Meadowlark 16-Inch Water Main Replacement
Solicitation Number: CO-00345-FG
Job No.: 18-4012

ADDENDUM #1
July 27, 2020

Sheet 5 of 28 – 16-INCH WATER PLAN SOUTHSIDE LIONS PARK (BEGINNING – STA 13+00.00)

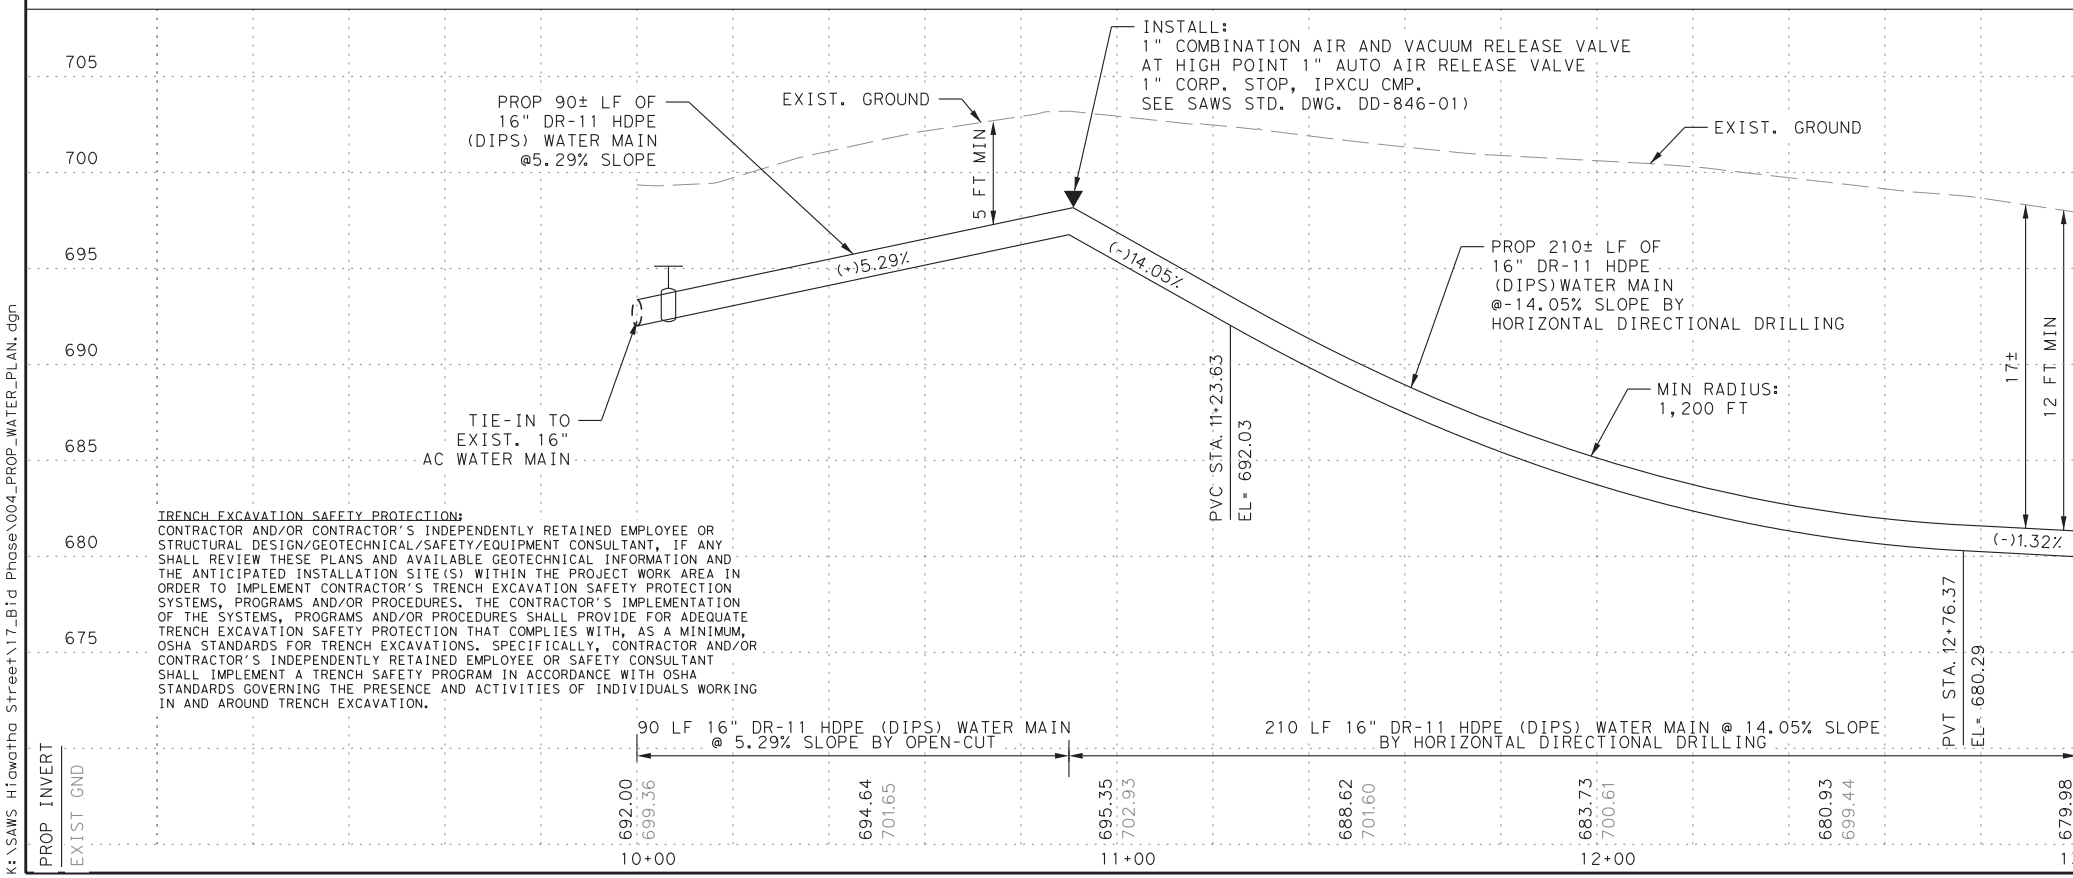
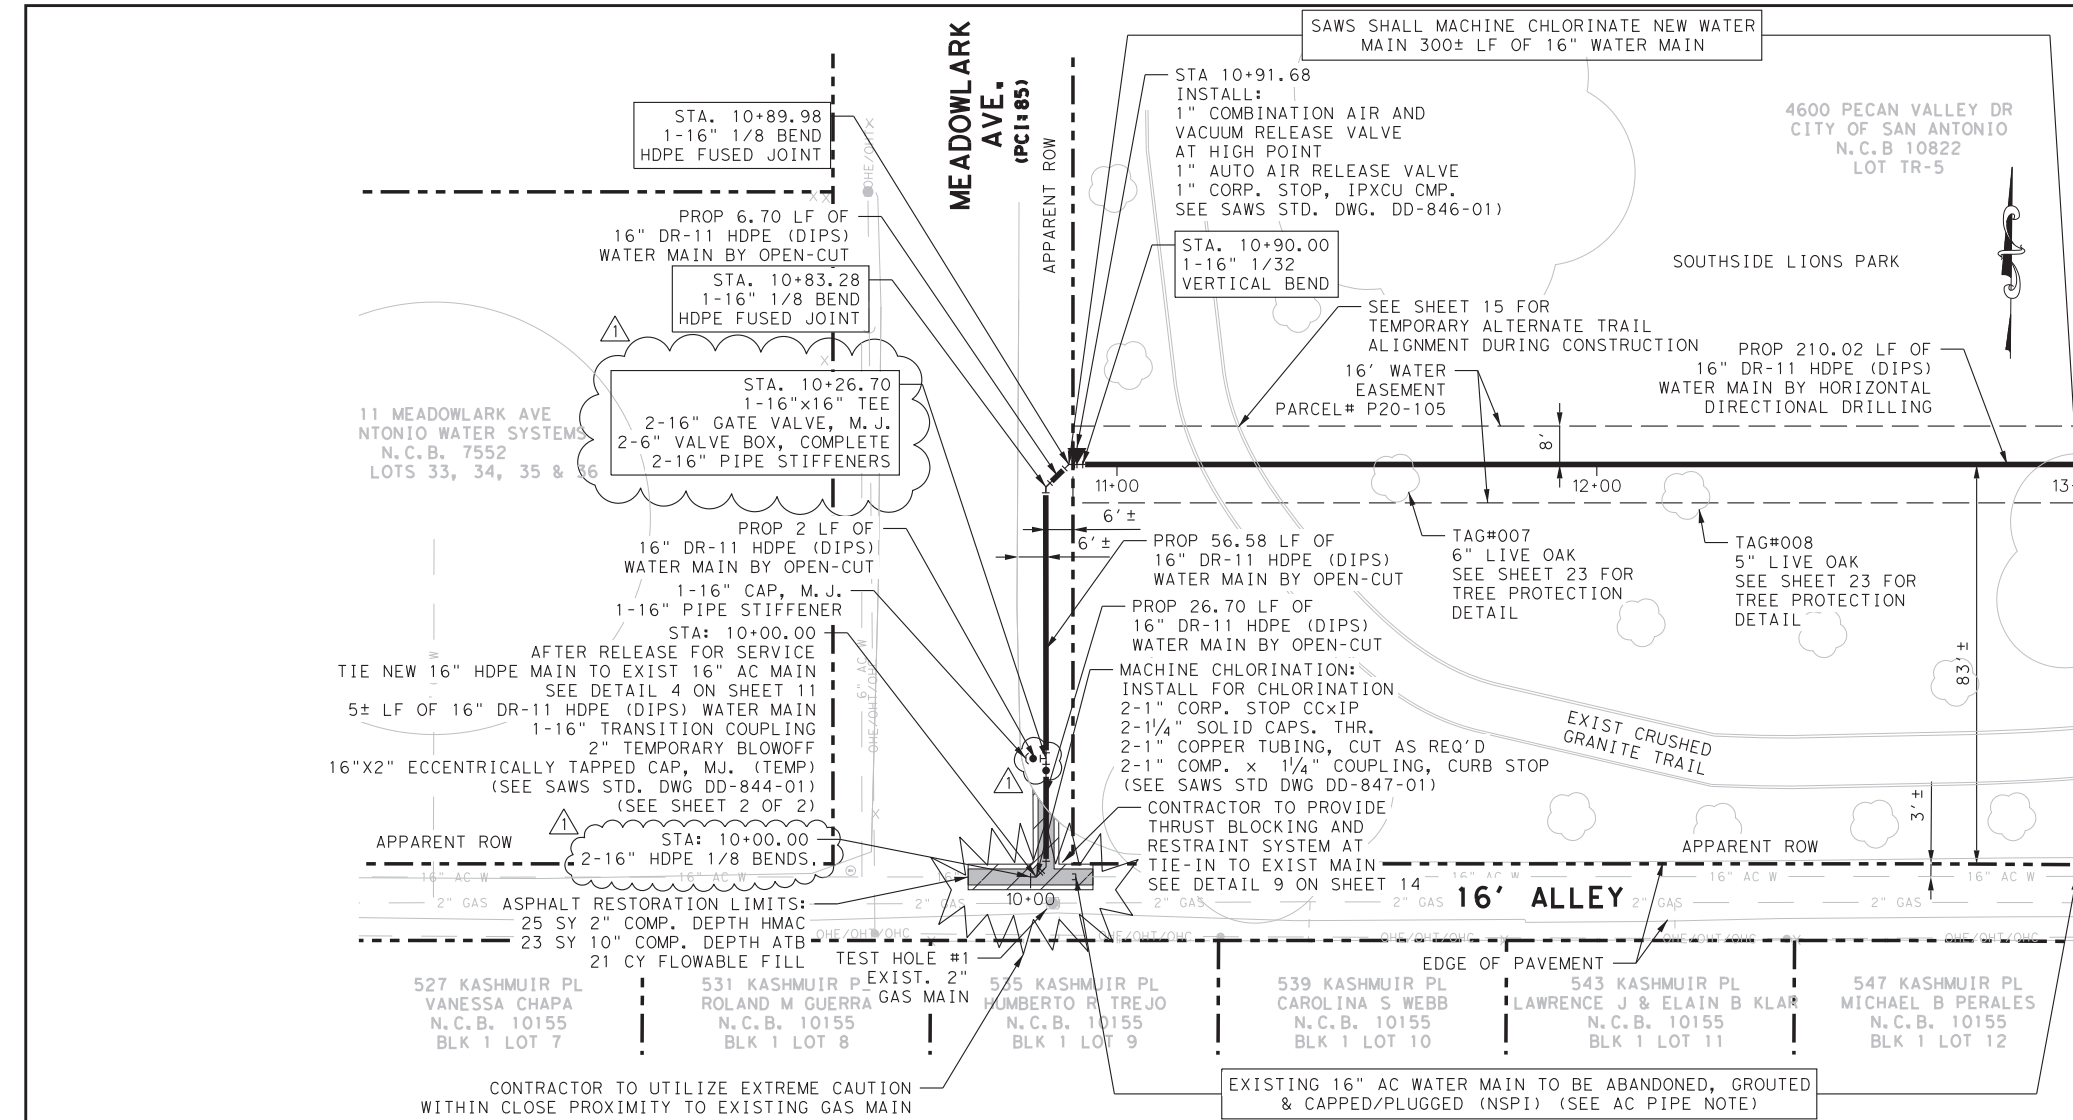
1. Sheet 5 of 28 Revision 1:

- a. Removed 16” Gate Valve and 6” Valve Box from Sta 10+00. Install 16” Gate Valve and 6” Valve Box at Sta 10+26.70 on branch line.
- b. Moved 16” Gate Valve and 6” Valve Box at Sta 10+26.70 from north side of Tee to south side of Tee.
